TO: Fairfield County Regional Planning Commission

SUBJECT: Meeting Notice and Agenda

SUBDIVISION: Eastland Career Center, New Lab Building – Preliminary Plan

Greenfield Township Zoning Resolution Amendment

POR Site Plan

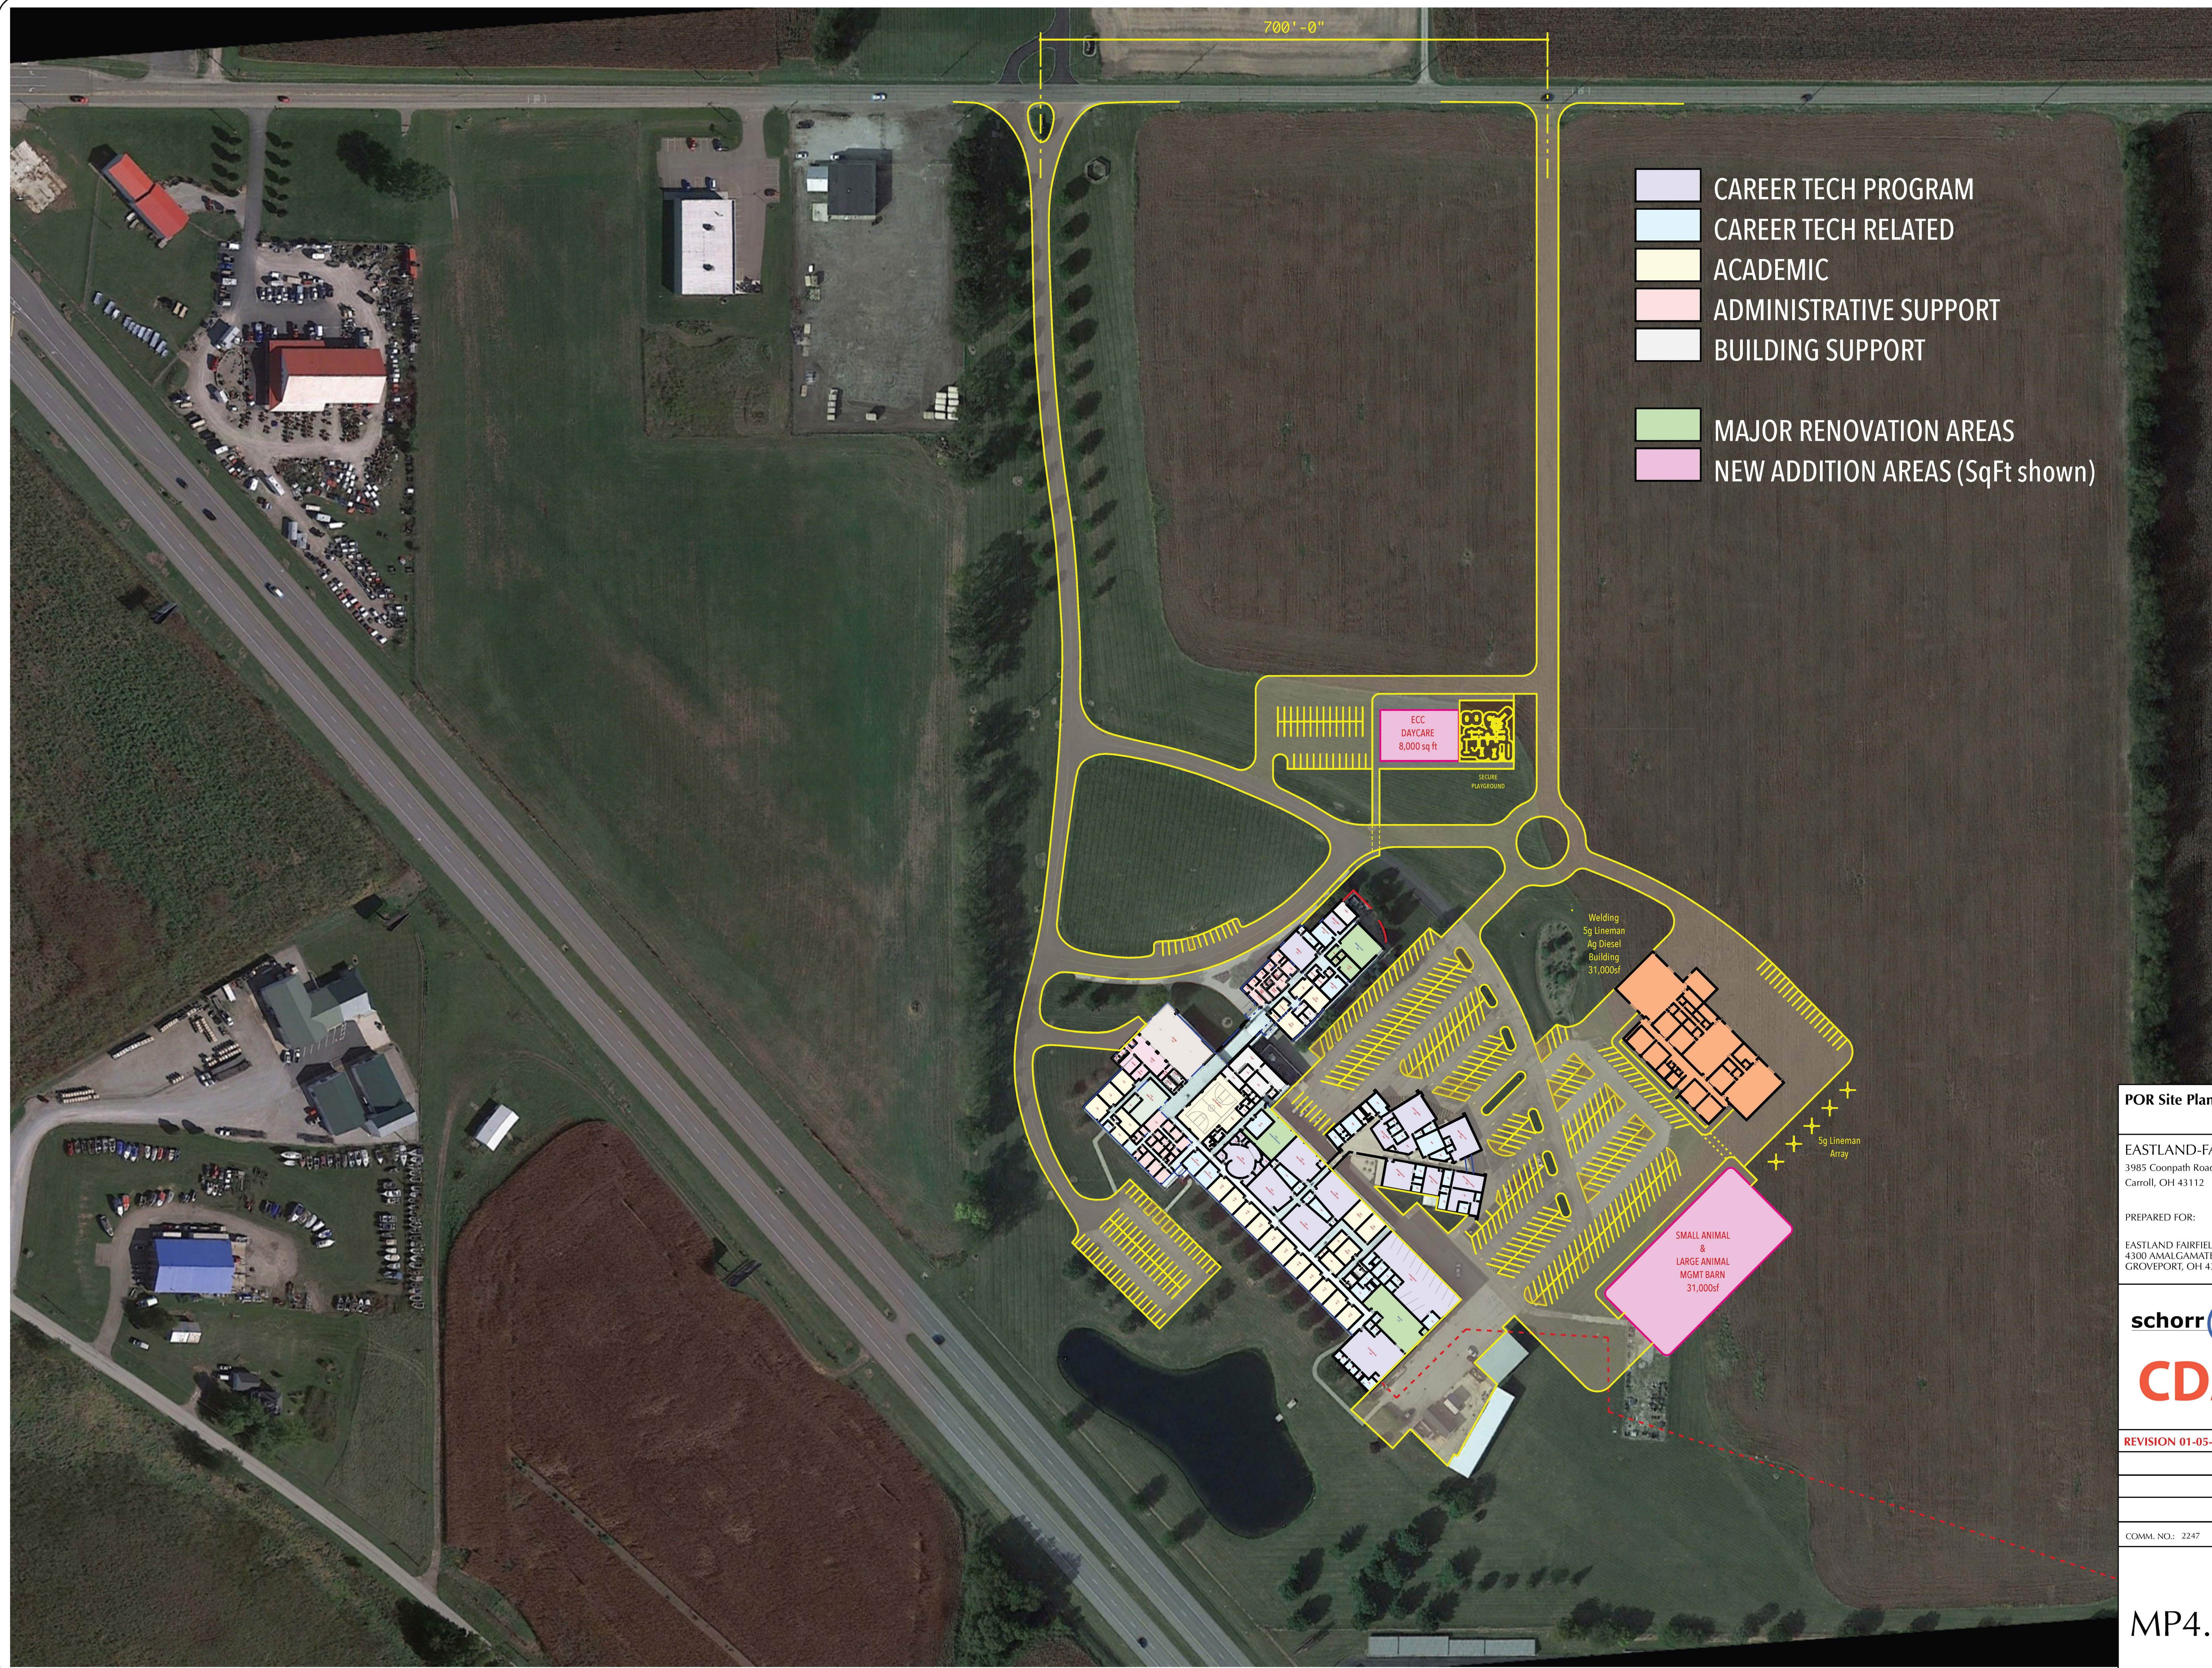
2. Although the Daycare Center building is not included in the preliminary plan, the Subdivision Regulations Committee recommends platting the entire property now in anticipation of its future construction.

3. The committee recommends removing (or blocking off) the existing driveway following the construction of the new driveway proposed in the preliminary plan.

4. The Subdivision Regulations Committee recommend conditional approval of the preliminary plan subject to the requirements of:
 - a. Technical Review Committee
